APP-GW-GLR-045-NS, Revision 1  
"Nuclear Island: Evaluation of Critical Sections"  
Technical Report Number 57

**TITLE: Nuclear Island: Evaluation of Critical Sections**

## **Nuclear Island: Evaluation of Critical Sections**

The AP1000 design has been certified for application at a hard rock site. Seismic analyses of the AP1000 at soil sites are described in Reference 3. The design of Nuclear Island structures was reconciled, and if needed, updated to address the seismic analyses results of Reference 3.

Figure 3H.5-10  
[Spent Fuel Pool Wall Divider Wall Element Locations]\*

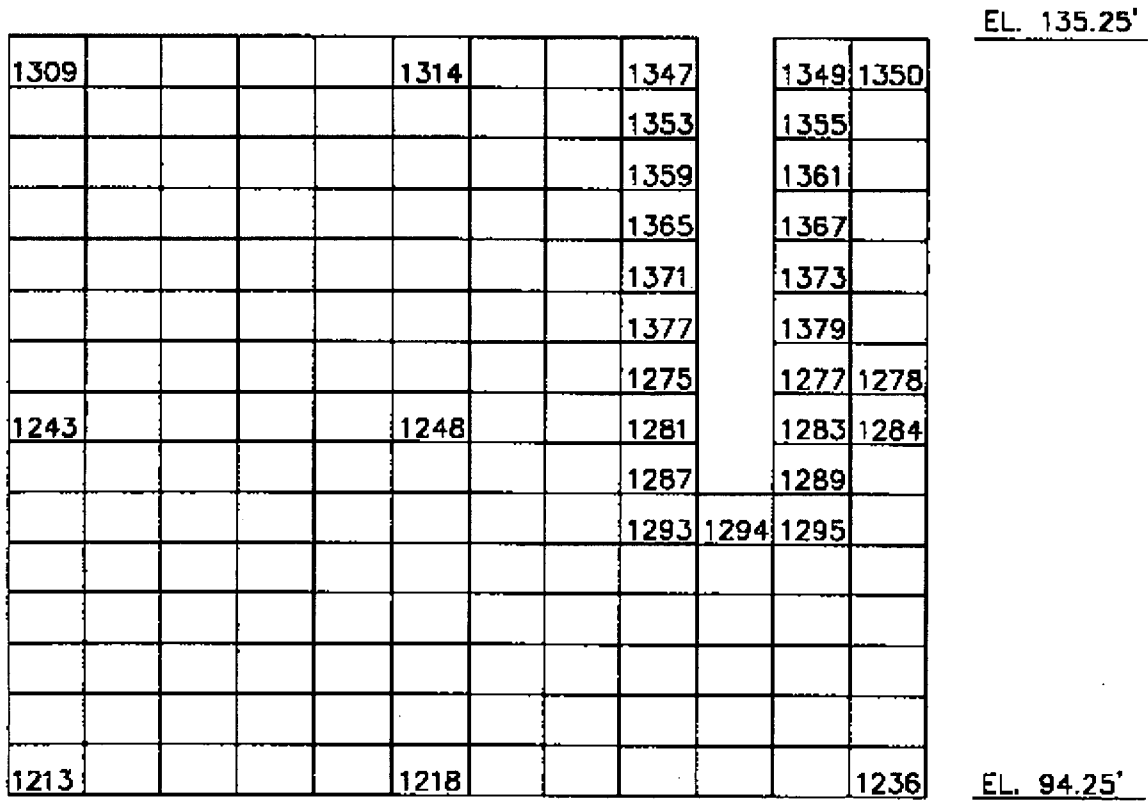
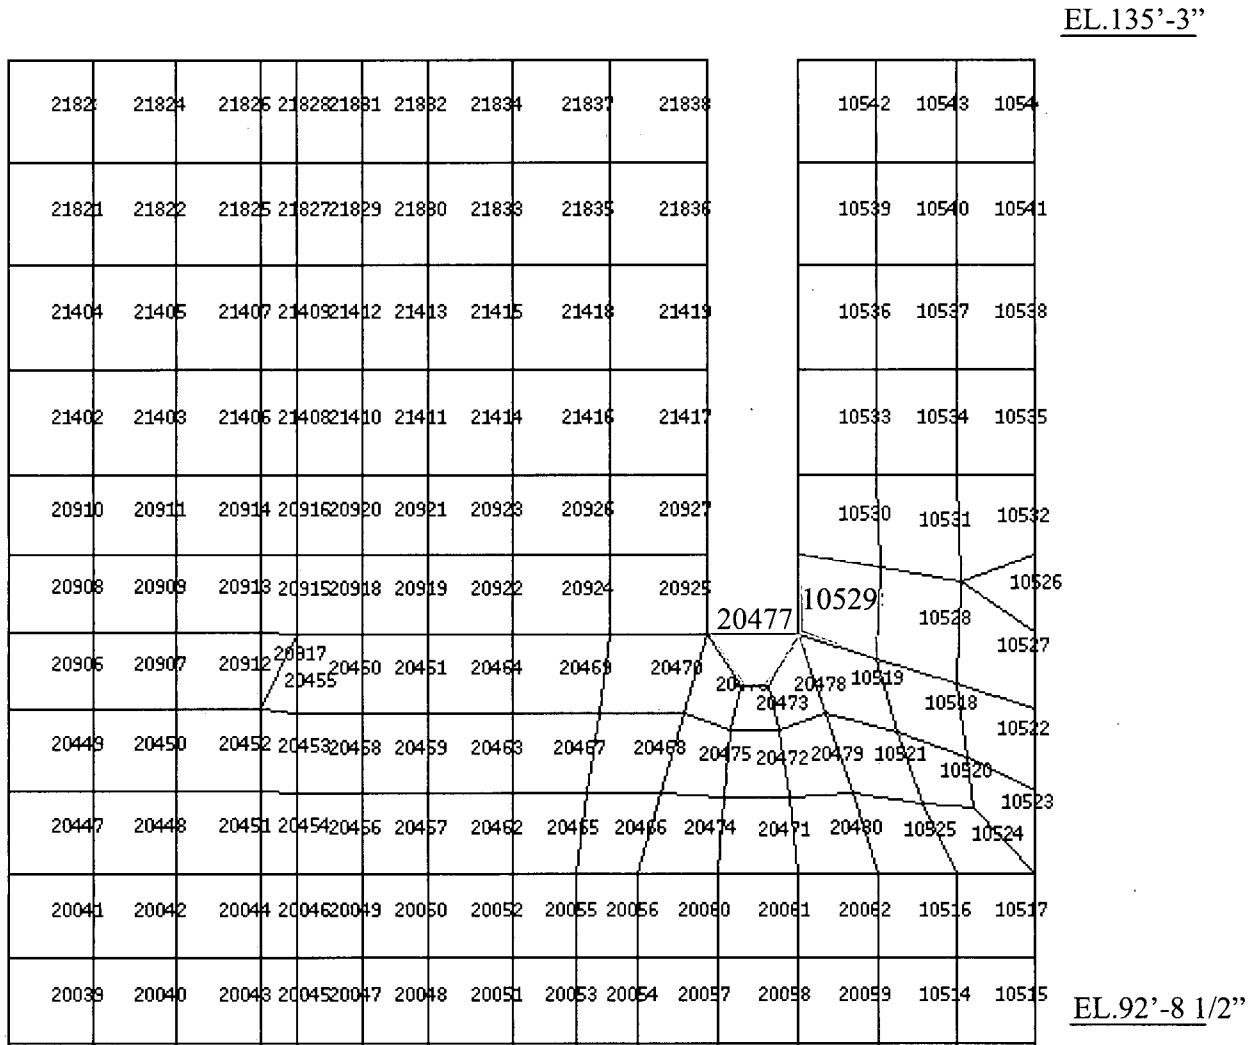
**Figure to be deleted**

**Figure to be inserted**

Figure 3H.5-2 (Sheet 1 of 3)

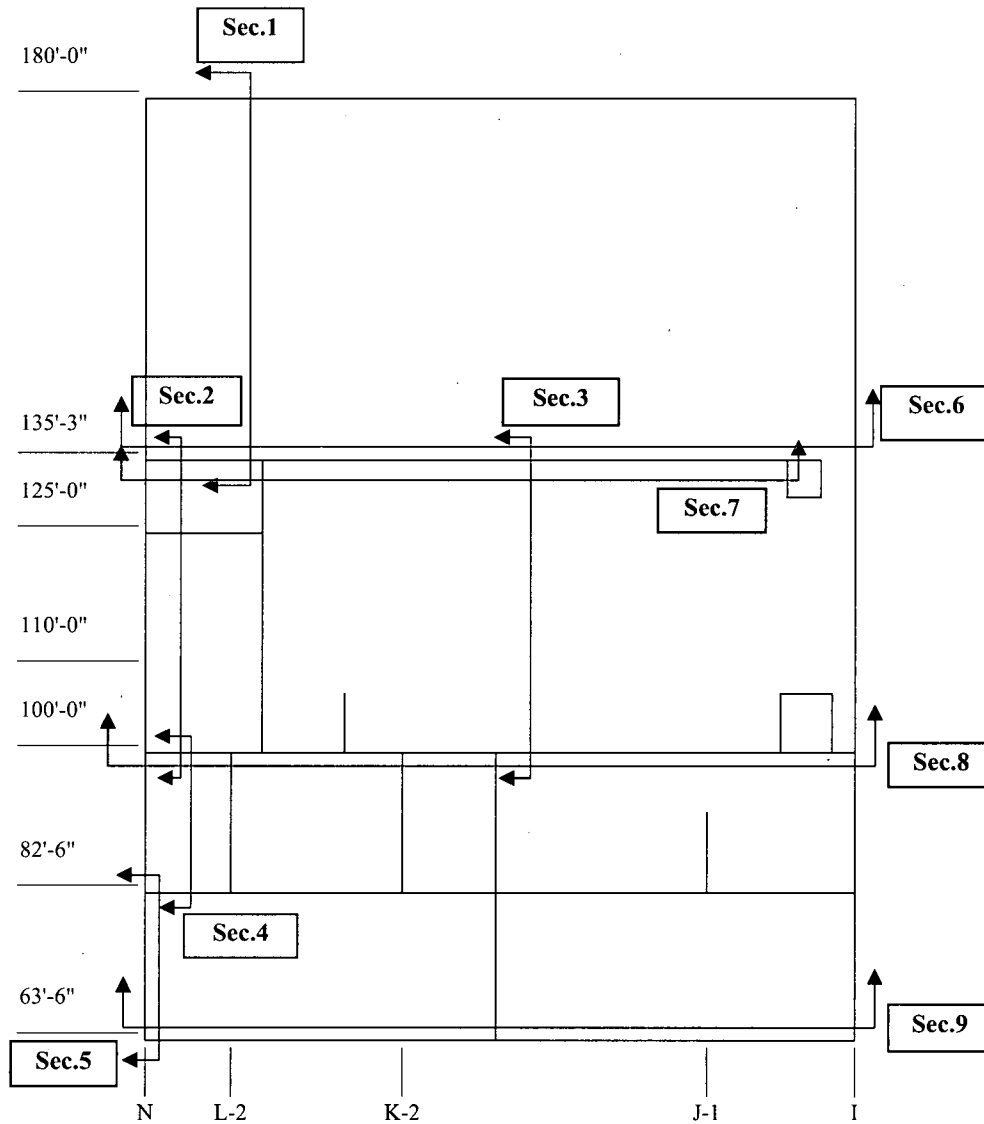
**Revise DCD Rev. 16 Figure as follows:**

Figure 3H.5-3

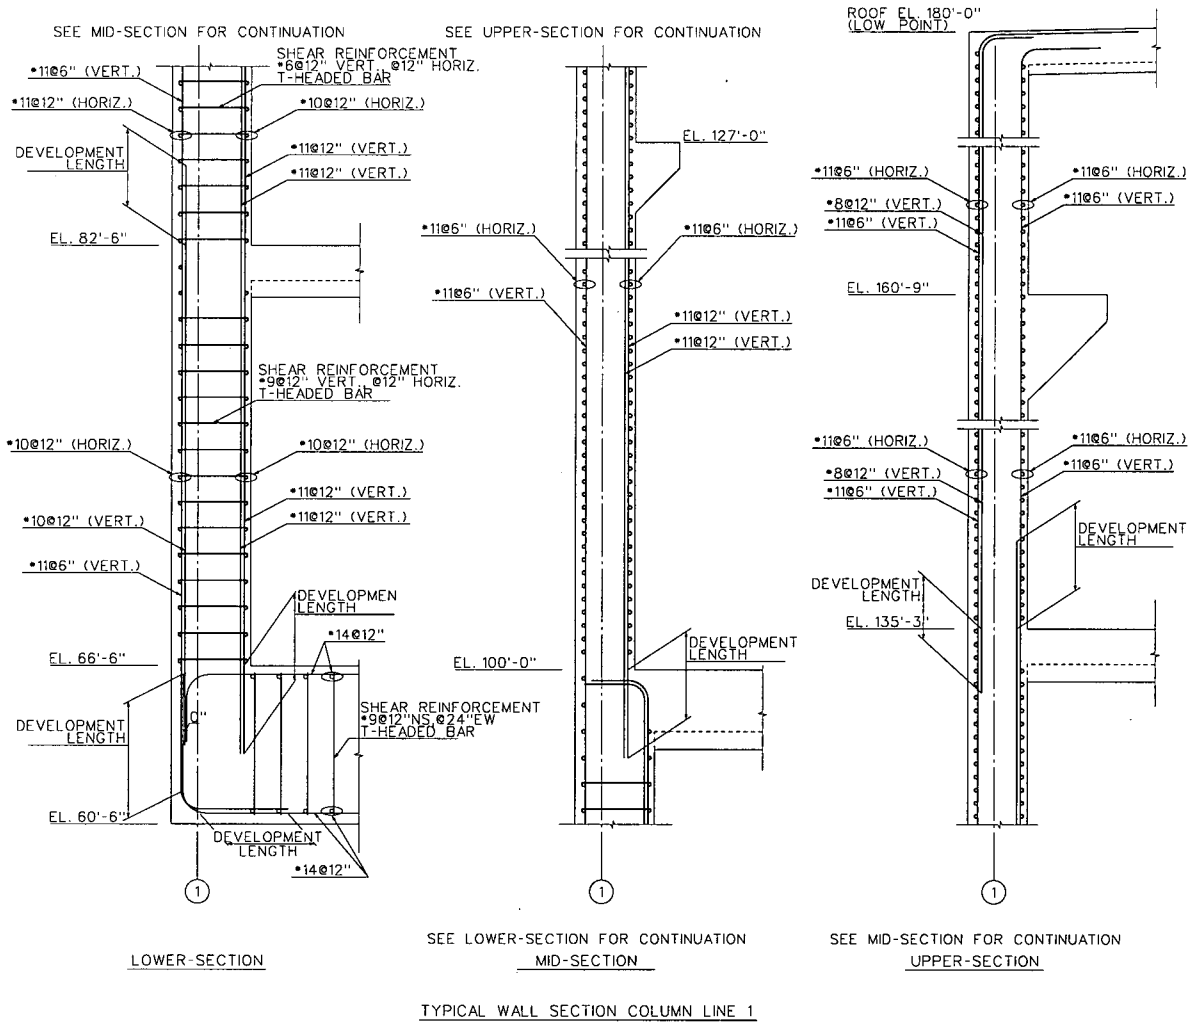
**Revise DCD Rev. 16 Figure as follows:**

Figure 3H.5-2 (Sheet 2 of 3)

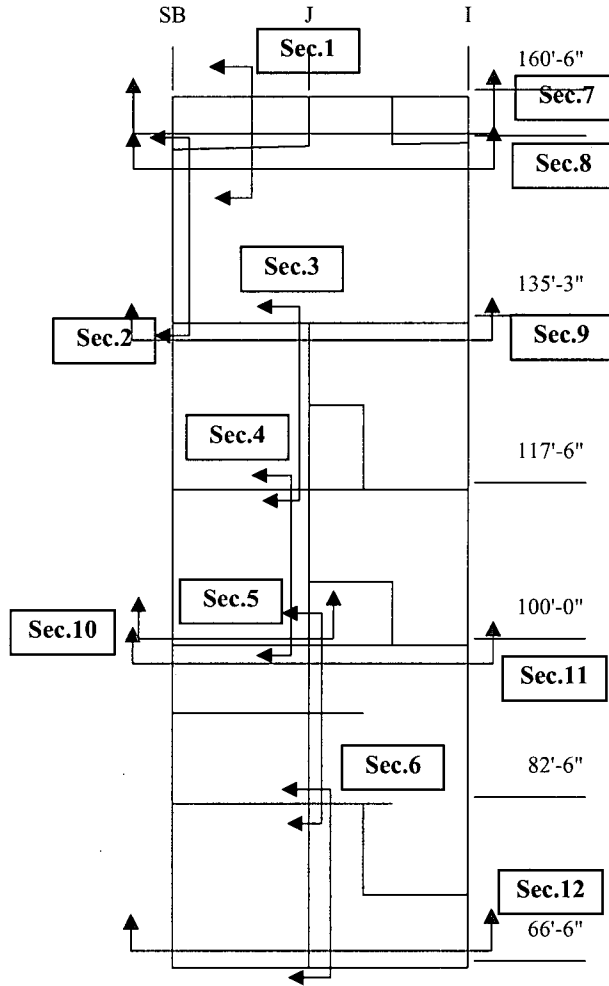
**Revise DCD Rev. 16 Figure as follows:**

Figure 3H.5-4

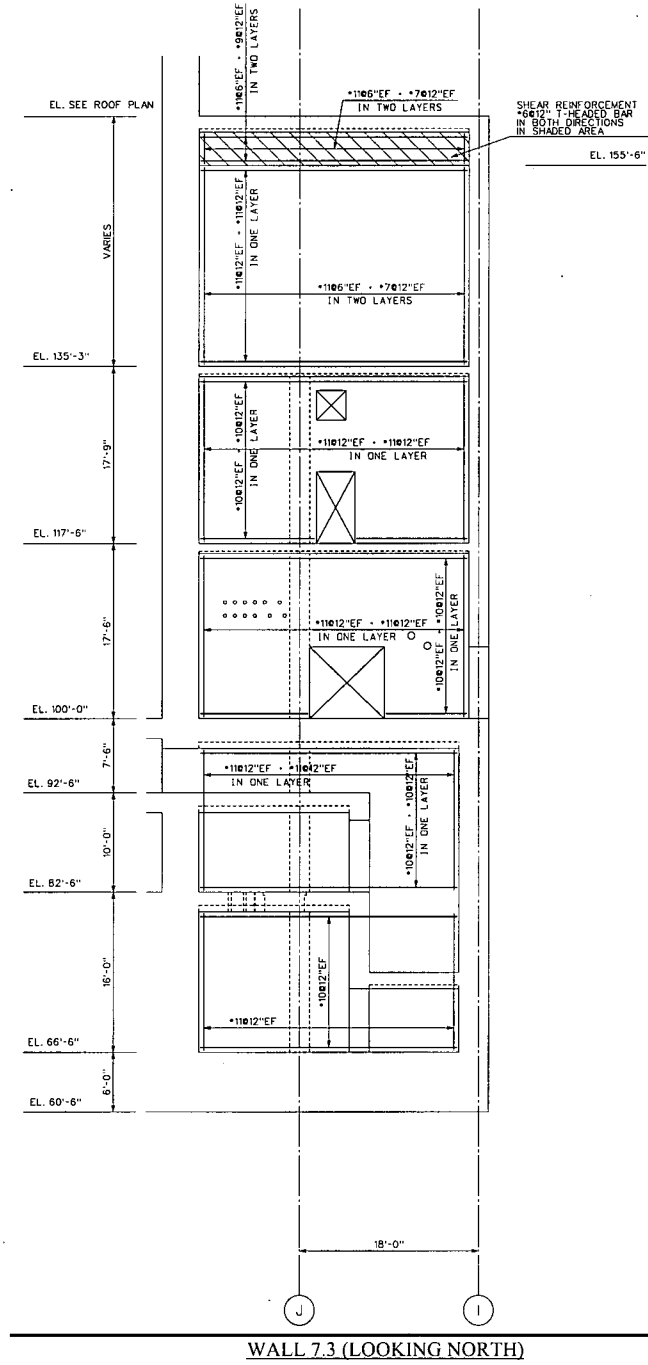
**Revise DCD Rev. 16 Figure as follows:**

Figure 3H.5-2 (Sheet 3 of 3)

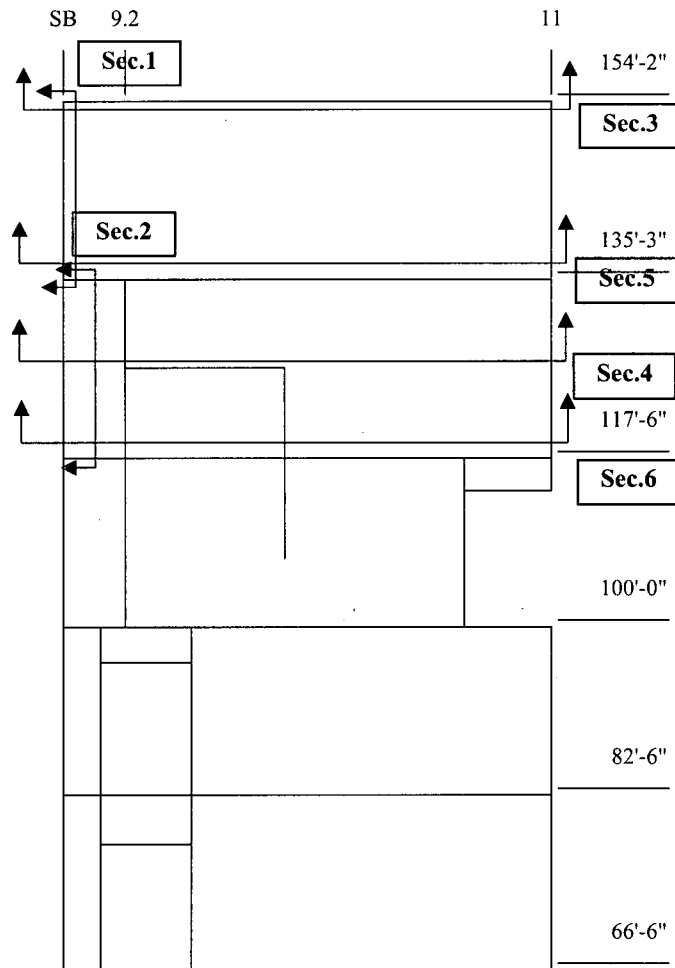
**Revise DCD Rev. 16 Figure as follows:**

Figure 3H.5-12

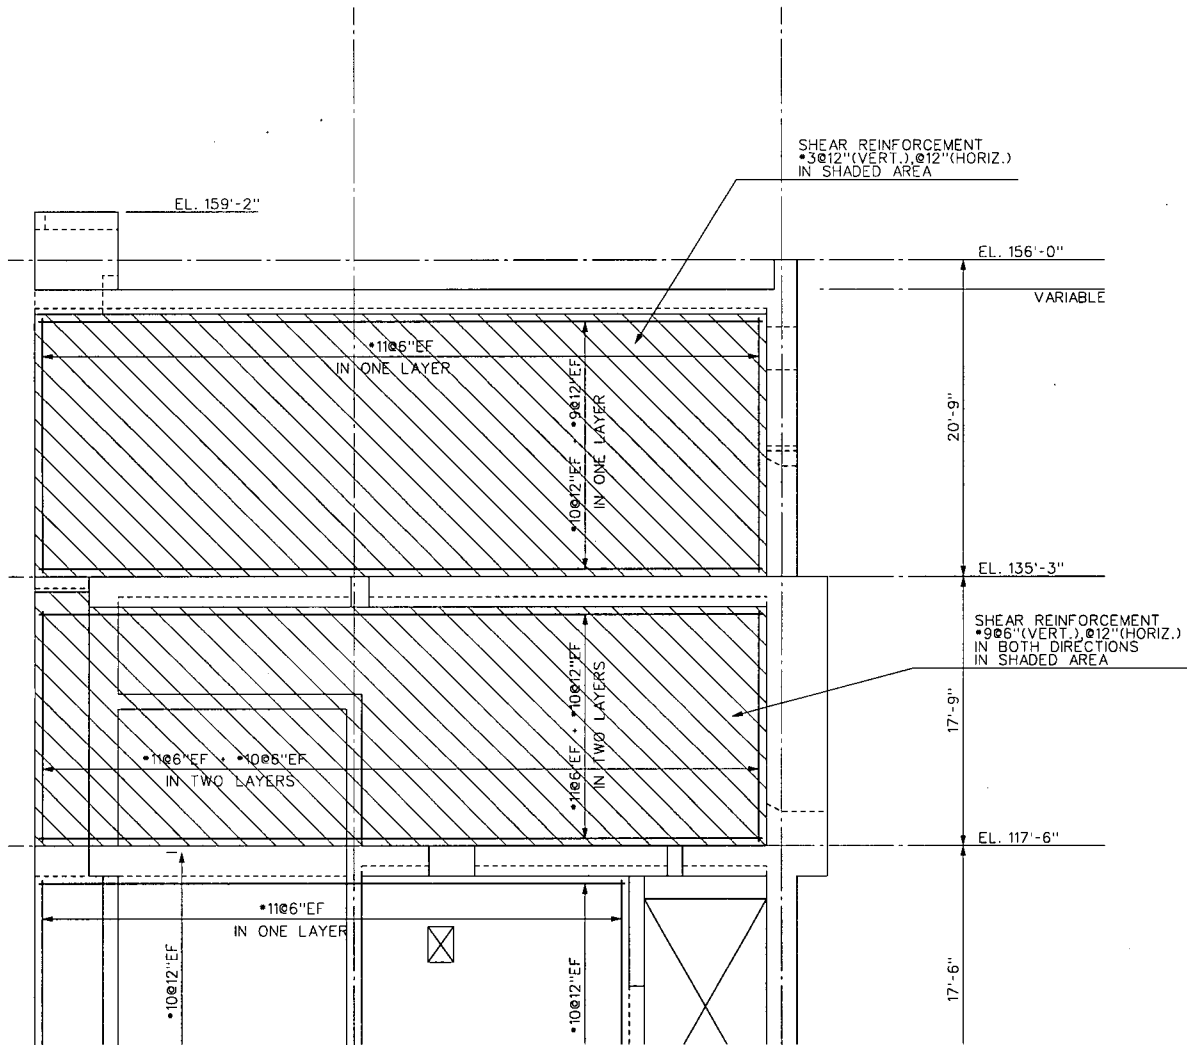
**Revise DCD Rev. 16 Figure as follows:**

Figure 3H.5-5 (Sheet 1 of 3)

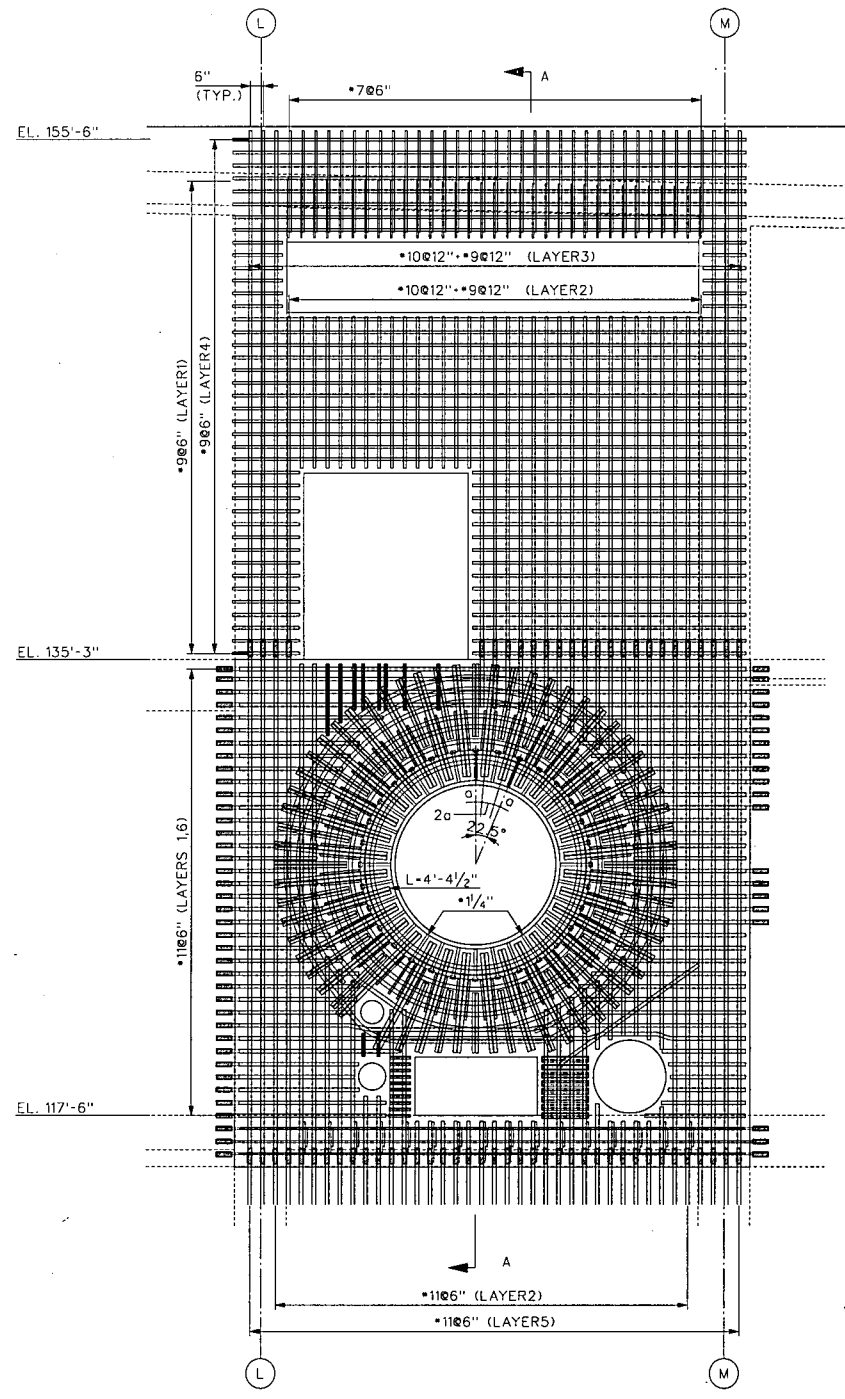
**Revise DCD Rev. 16 Figure as follows:**

Figure 3H.5-5 (Sheet 2 of 3)

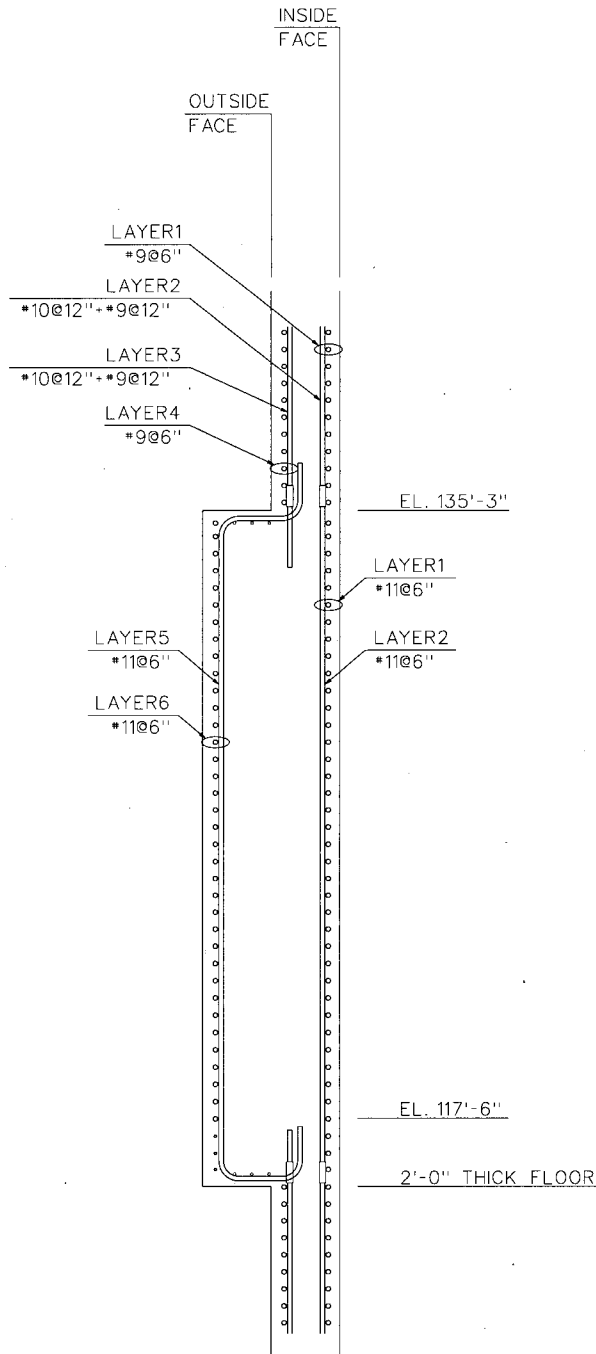
**Revise DCD Rev. 16 Figure as follows:**

Figure 3H.5-5 (Sheet 3 of 3)

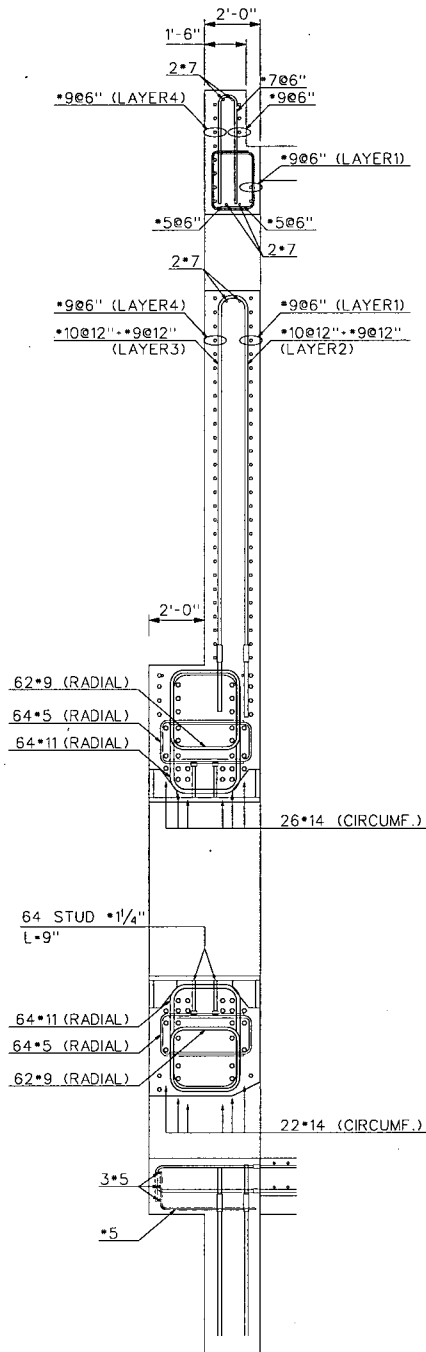
**Revise DCD Rev. 16 Figure as follows:**
